## Response to Public Comment

### *Reconnecting Cincinnati Westway Design Improvements*

**RE:** Brent Spence Bridge Corridor Project | ODOT PID 89068 | KYTC Project Item No. 6-17

Figure 1: Schematic Depiction of Lowered I-75 Concept with Frontage Road Intersections

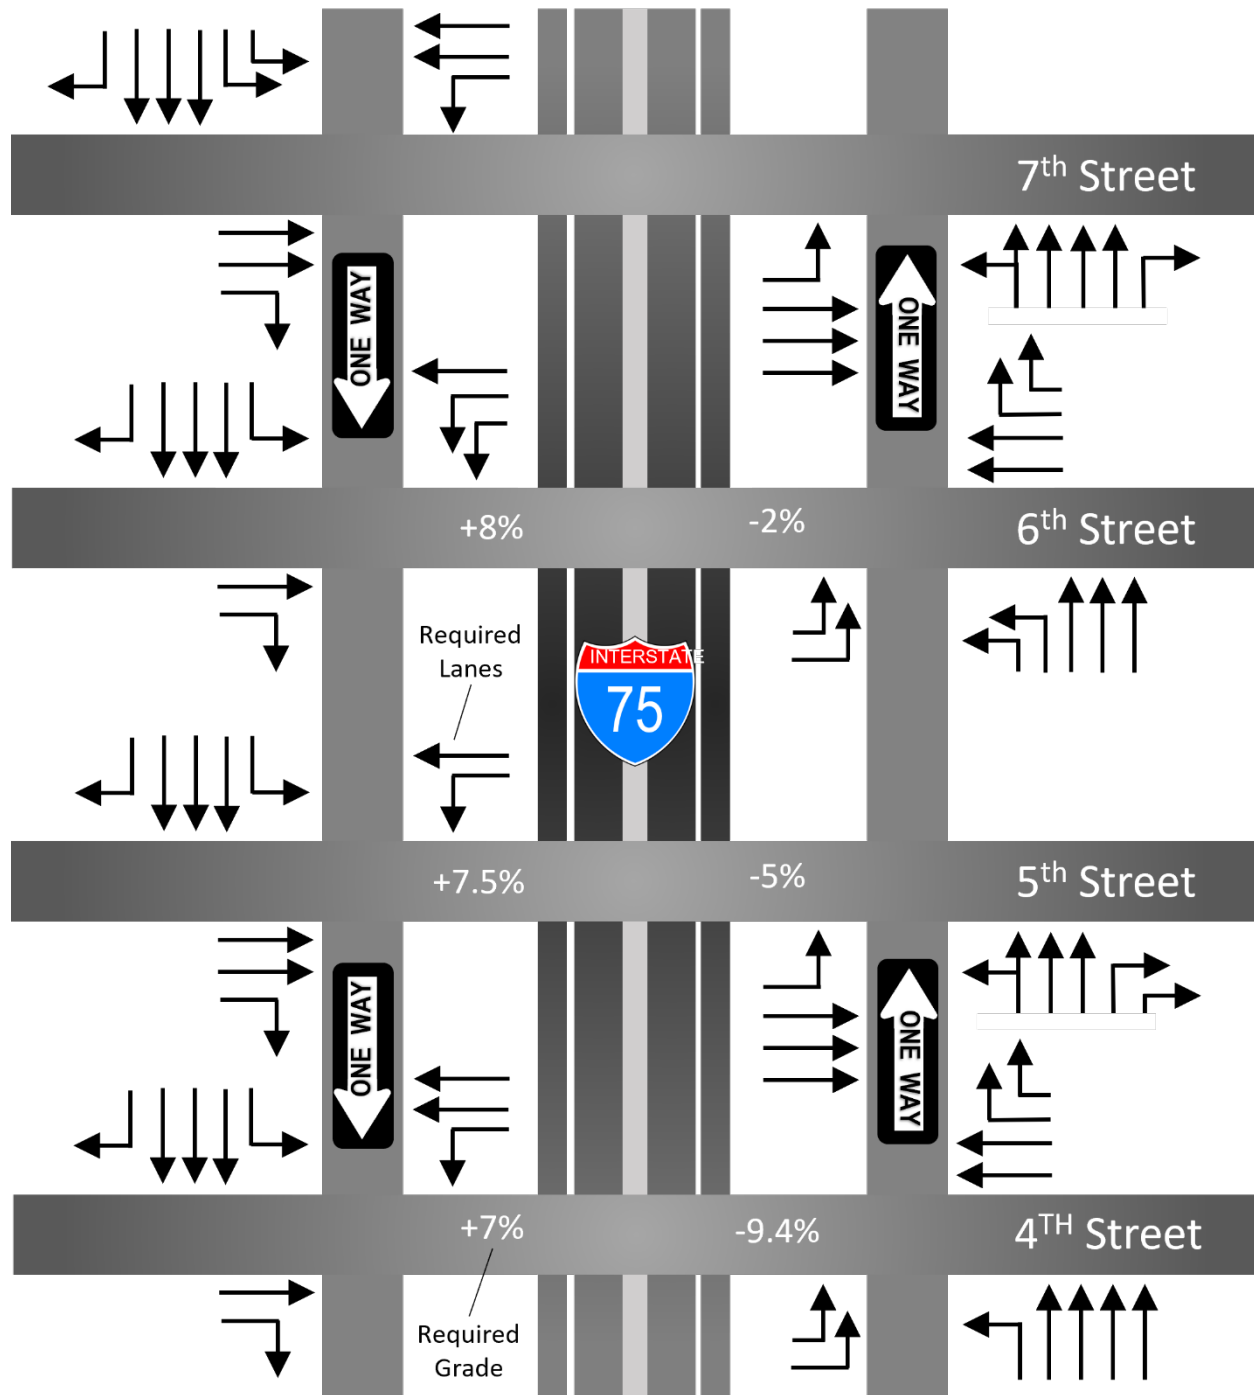
The Westway Emails suggest extending the local street grid over I-75 to better connect the Cincinnati Central Business District (CBD) to Queensgate and the West End and to accommodate additional street-facing development. The geometric constraints discussed previously also affect the design of local cross streets. Because the I-75 mainline and access ramps cannot be depressed further, Cincinnati's cross streets must be raised substantially if they are reconfigured in a grid-type configuration that passes over I-75. These changes would require grades ranging from 5 to 9 percent on 4<sup>th</sup> Street, 5<sup>th</sup> Street, and 6<sup>th</sup> Street<sup>1</sup> (see Figure 1 and Attachment 2). ODOT's *Location and Design Manual, Volume 1* lists the maximum grade for urban arterial roadways as 7 percent. However, the manual states that maximum design grades should be used infrequently, rather than a value to be used in most cases. These required grades would not support a “capped” design for the BSB corridor. Furthermore, grades of this magnitude are not only undesirable for vehicular traffic, but they also present substantial mobility and accessibility concerns for cyclists and pedestrians. The Americans with Disabilities Act (ADA) requires facilities that accommodate pedestrians to be constructed with grades of 5 percent or less.

The Westway Emails maintain that the final width of the BSB Corridor should be no larger than the width of Fort Washington Way. A high-level screening of traffic operations was conducted using available traffic data to determine the minimum number of lanes required to provide acceptable levels of service<sup>2</sup> for a roadway configuration similar to Fort Washington Way, which includes parallel frontage roads on both sides of the interstate. Based on the screening, the frontage roads would require three to four lanes for through traffic with additional left and right turn lanes at each intersection to eliminate any adverse operations on the freeway system. The local cross streets would also require additional lanes for turning traffic. The minimum lanes required for a configuration similar to Fort Washington Way are depicted schematically in Figure 1.

**Figure 2: West 7<sup>th</sup> Street Bridge Over I-75 (Looking East)**

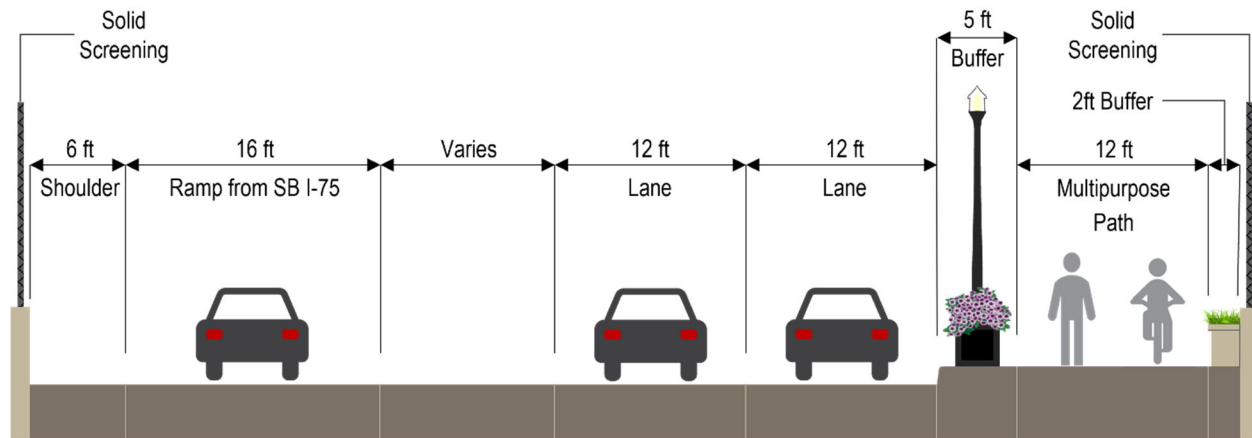
The Westway Emails advocate for local streets that are “designed in a way that is safe and enjoyable for pedestrians and cyclists to navigate and in a way that is supportive of local businesses and conducive to urban development.” KYTC and ODOT fully support these priorities. To that end, the preferred alternative maintains existing sidewalk connections and adds new pedestrian and bicycle shared use paths parallel to and across I-71/I-75. Bike lanes will also be added in some locations (see Attachment 4). The multi-modal features incorporated into the BSB Corridor Project will connect to and enhance existing pedestrian and bicycle facilities in the Cincinnati and Covington areas. In addition, aesthetic guidelines developed for the project will guide the design of multi-modal facilities to provide a network that is not only safe and utilitarian, but enjoyable. Multi-modal facilities will help to create a “sense-of-place” for residents that will be compatible with local, urban land uses. Figure 2 shows an example of the multi-modal facilities that will be incorporated into the design of West 7<sup>th</sup> Street bridge over I-75 in Cincinnati.

Attachment 1: BSB Corridor Project Tiered Bridge System

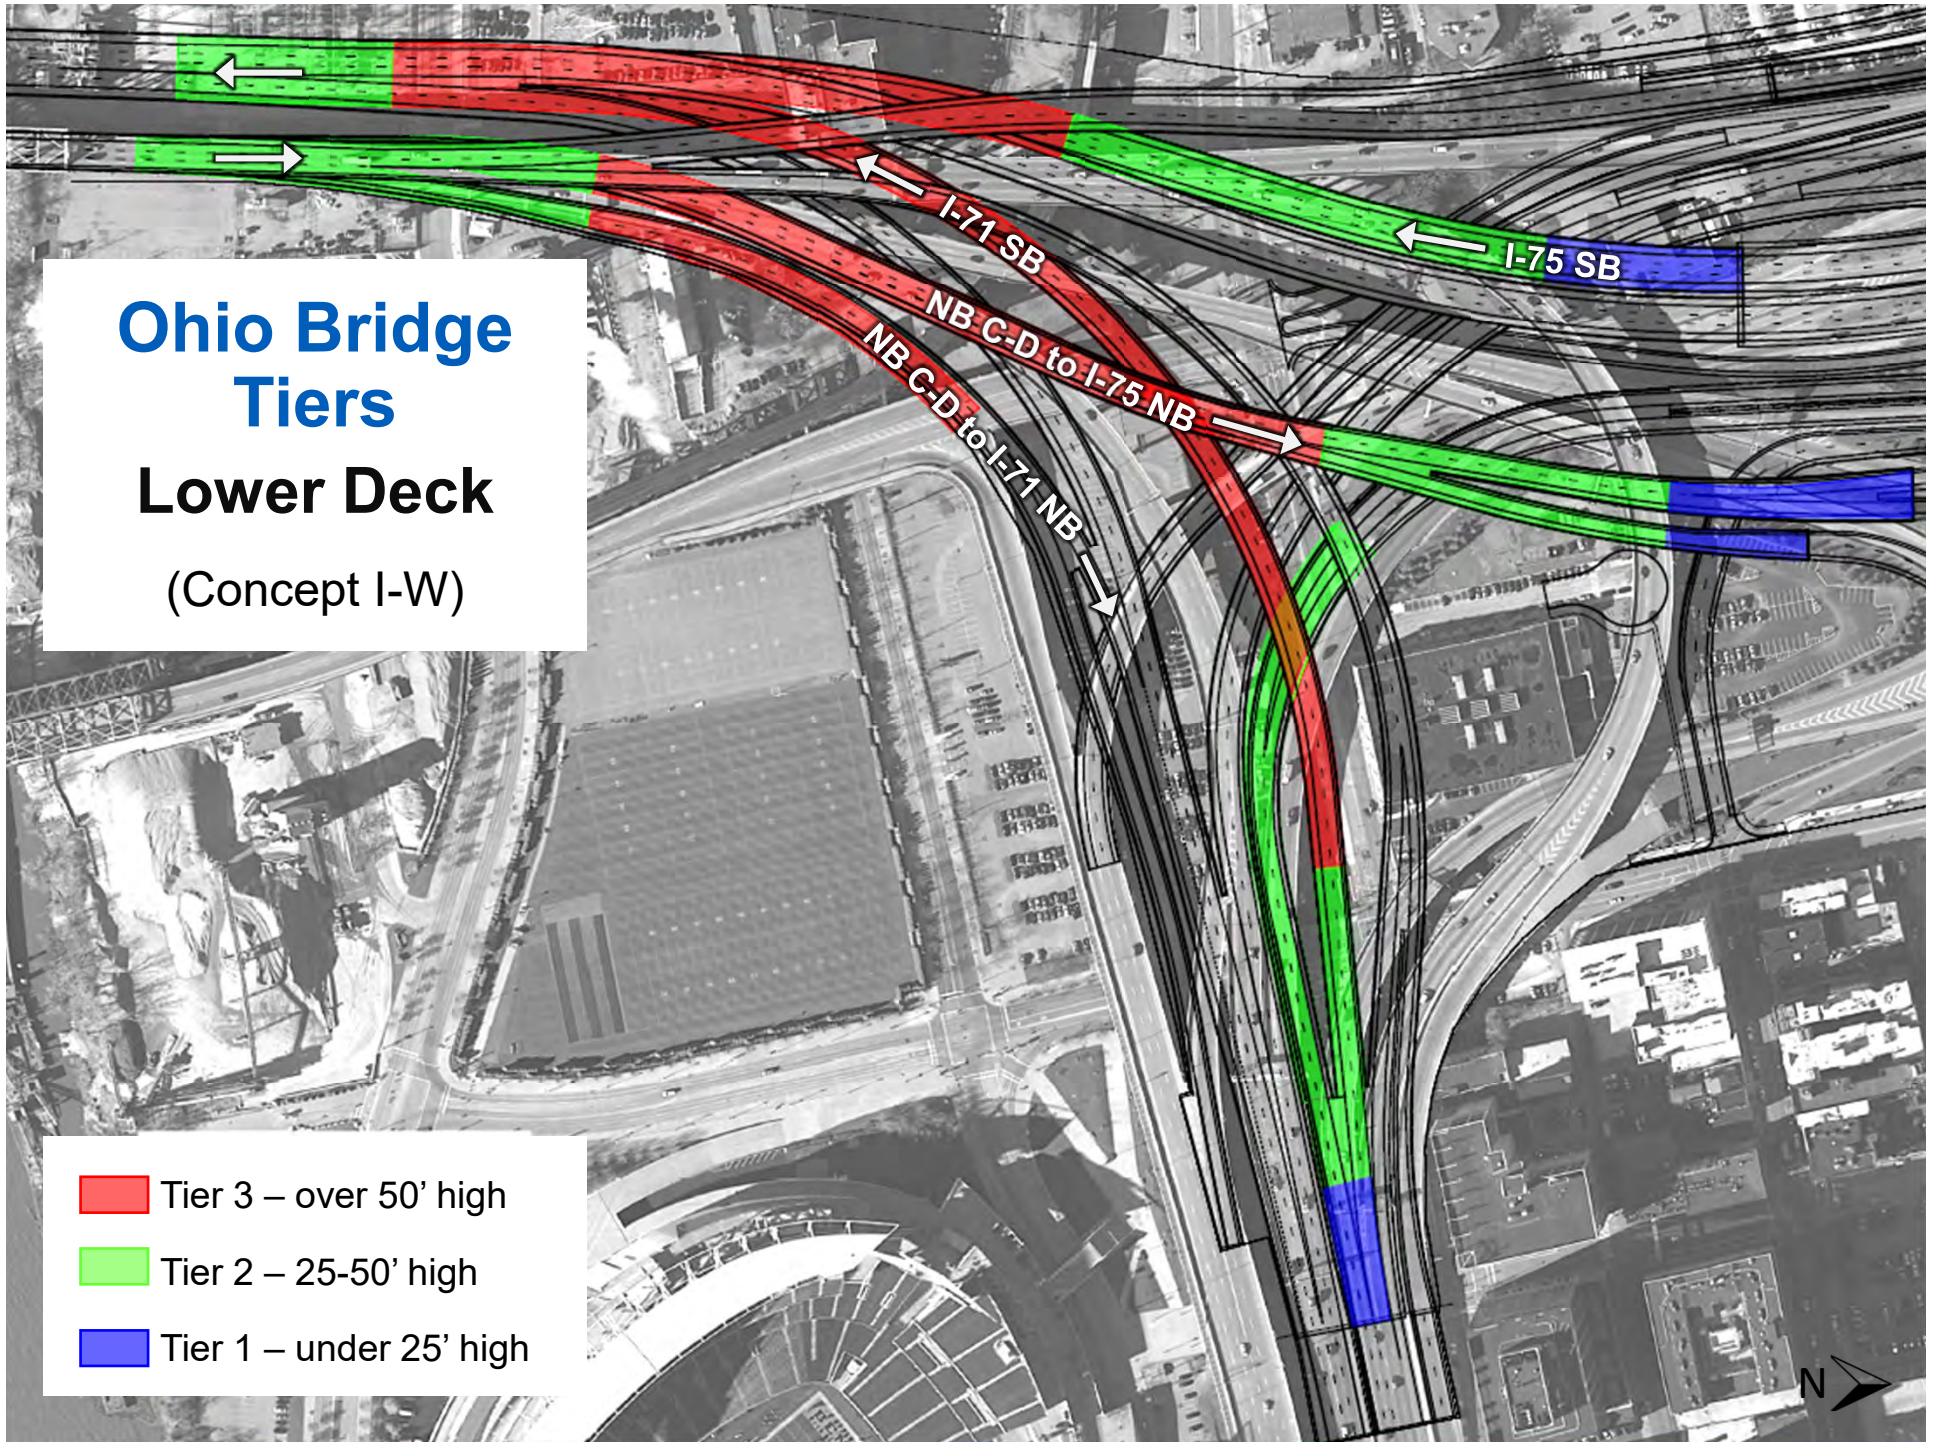
- Any bridge over the Ohio River must meet U.S. Coast Guard clearance requirements, which means the bottom of the bridge will need to be 55 feet above the flowline of the Ohio River.
- Once the interstate passes over the Ohio River, it cannot descend directly into downtown Cincinnati. First, it must stay elevated to cross active CSX rail lines between Pete Rose Avenue and 3<sup>rd</sup> Street.
- Any design must accommodate a complicated system of mainline and ramp movements to provide local access and continuity along I-71, I-75, and US 50. Weaving these ramps through the project area requires a complex tiered bridge system with the highest tier rising over 50 feet above the ground (see Attachment 1).

To meet these geometric constraints, the preferred alternative for the BSB Corridor Project currently descends toward downtown Cincinnati at a 4- to 5.5-percent grade. Lowering the roadway any further would require substantially steeper roadway grades (up to 7.7 percent). For reference, ODOT's *Location and Design Manual, Volume 1* lists the maximum grade for urban interstates in similar terrain as 6 percent. Furthermore, given the complicated geometry, any changes to the mainline profile would cascade throughout the BSB interchange area, resulting in prohibitively steep grades along other ramps and C-D roads. Introducing grades of this magnitude would require design exceptions and present traffic operational and safety concerns, particularly considering the high volumes of heavy truck traffic traveling through the corridor. This would be contrary to the project's approved purpose and need, which includes improving traffic flow and safety and correcting geometric deficiencies through a key regional and national transportation corridor.
